CENTRAL LIBRARY
ACCESSIBILITY SURVEY

July, 2007

CITY OF SANTA
BARBARA

Building - Photo # 8

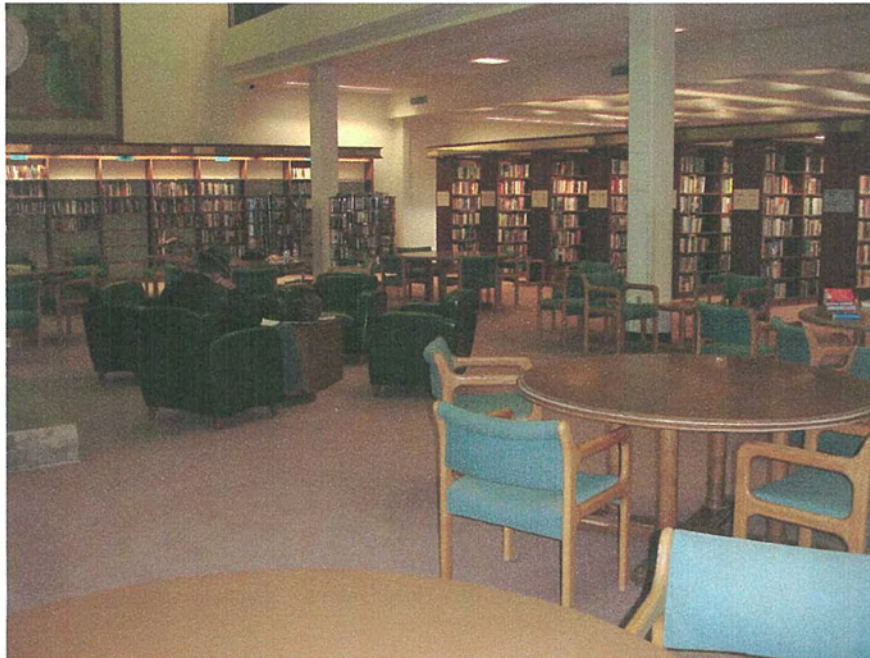
Book return mounted on check-out counter is too high 41" and does not have a low section of 34" maximum height by 36" wide minimum for wheelchair users

Building - Photo # 12

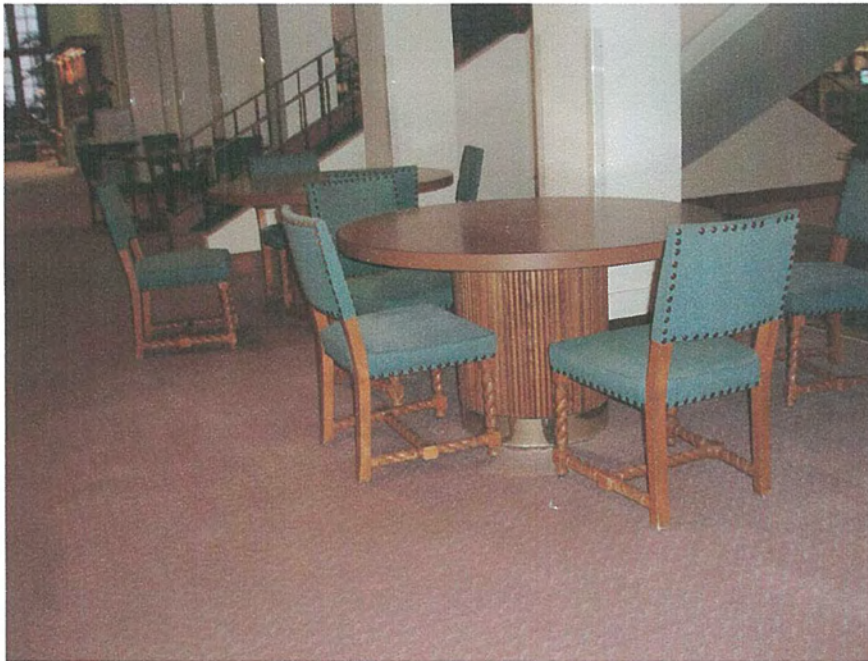
Reading tables does not have the required knee clearance due to the leg configuration. 17" deep by 30" wide clear required.

Building - Photo # 18

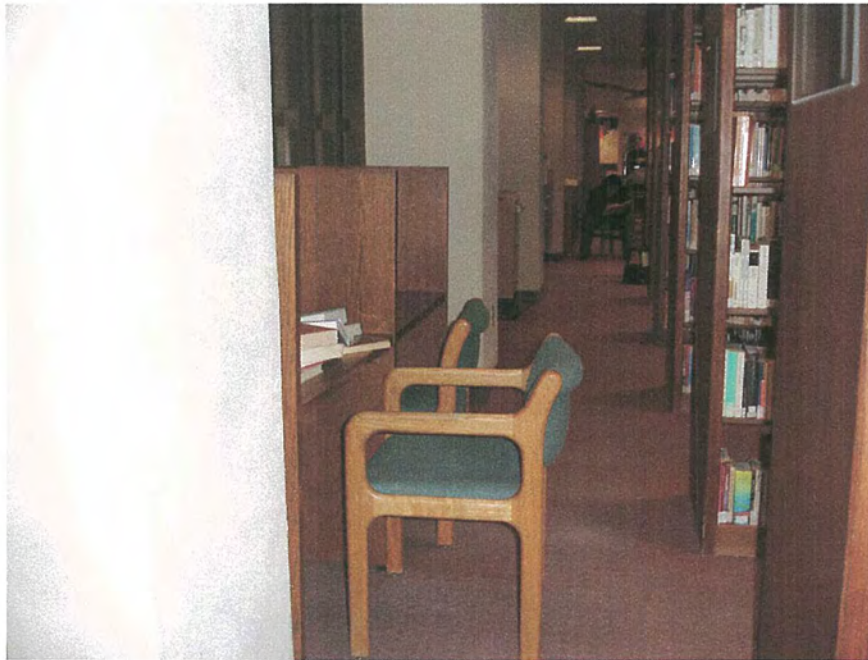
Underside of the stairs below 80" high does not have a cane detectable area for blind pedestrians at the floor level or within 27" high maximum.

Building - Photo # 24

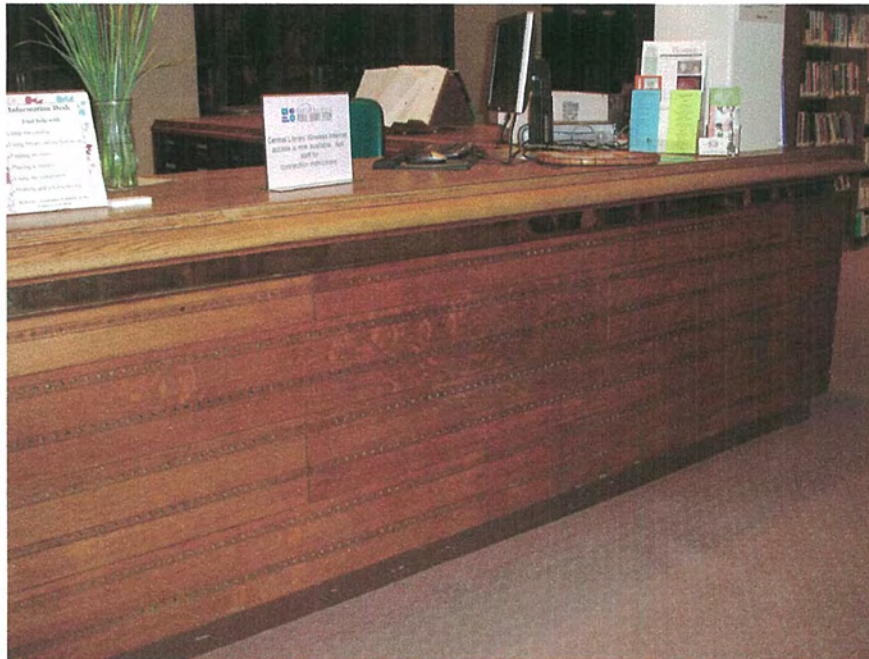
Children reading tables do not have the required wheelchair clearance 20" wide between legs.

Building - Photo # 29

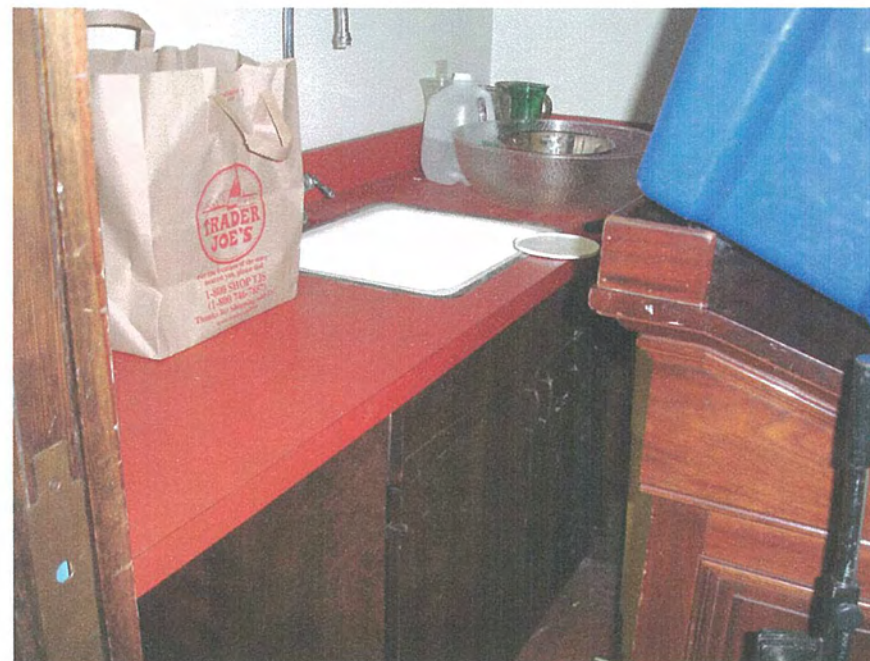
Boys and girls restrooms are inaccessible, too small without wheelchair maneuverable clearance, grab bars, strobe lights.

Building - Photo # 46

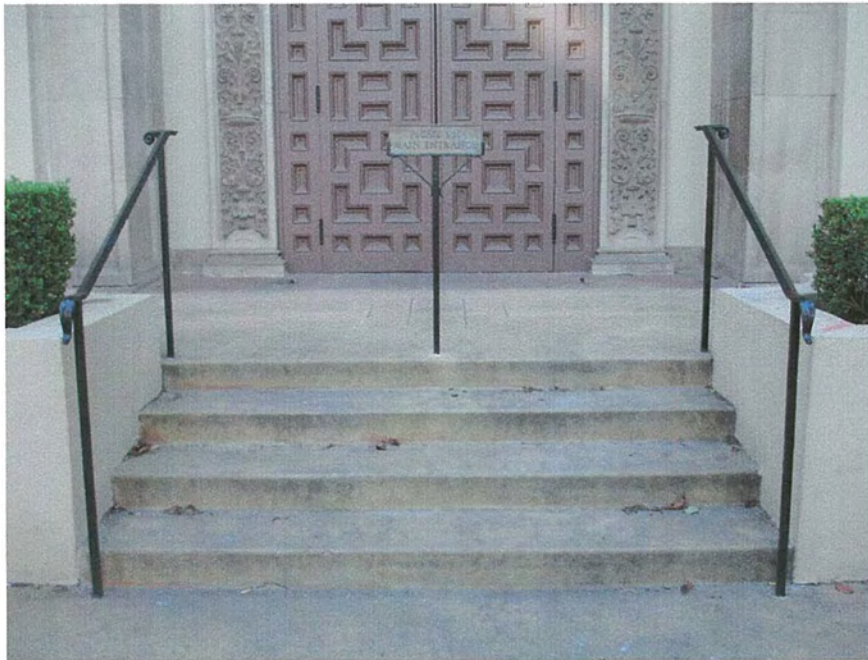
Panic bar protrudes 5" into the path of travel – maximum protrusion allowed by code above 27" is 4".

Building - Photo # 7

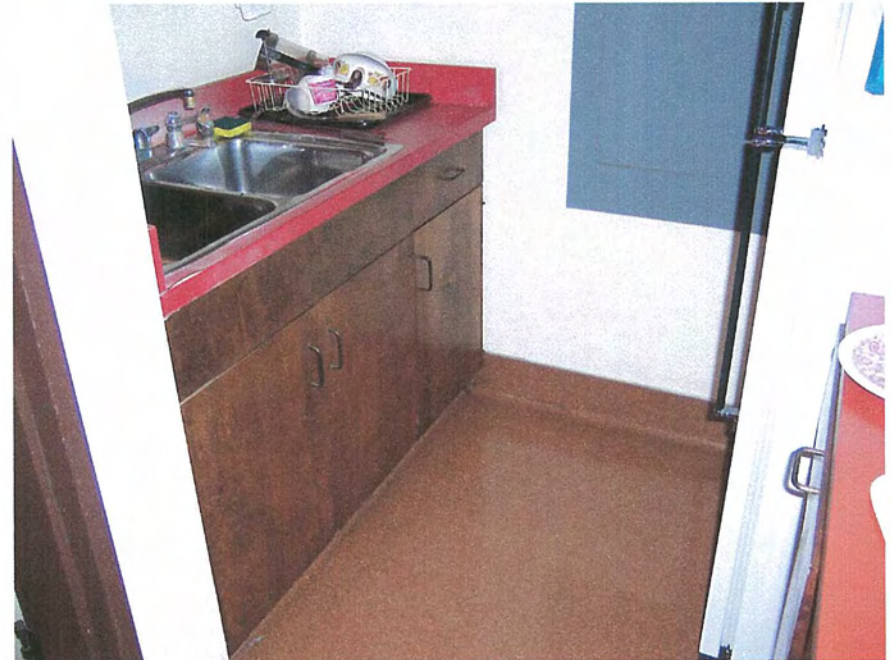
Stairs do not have contrasting color striping. Handrails do not have the required extensions.

Building - Photo # 13

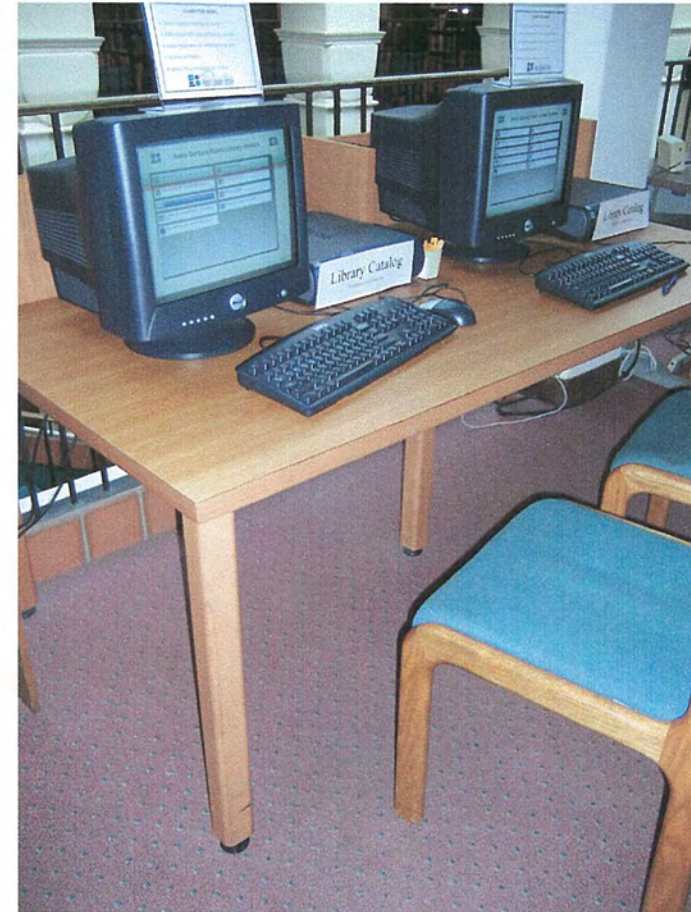
Restroom is too small and not wheelchair accessible, it does not have the required maneuverable clearances, grab bars, strobe lights. Sink does not have the required knee clearance; mirror is mounted too high.
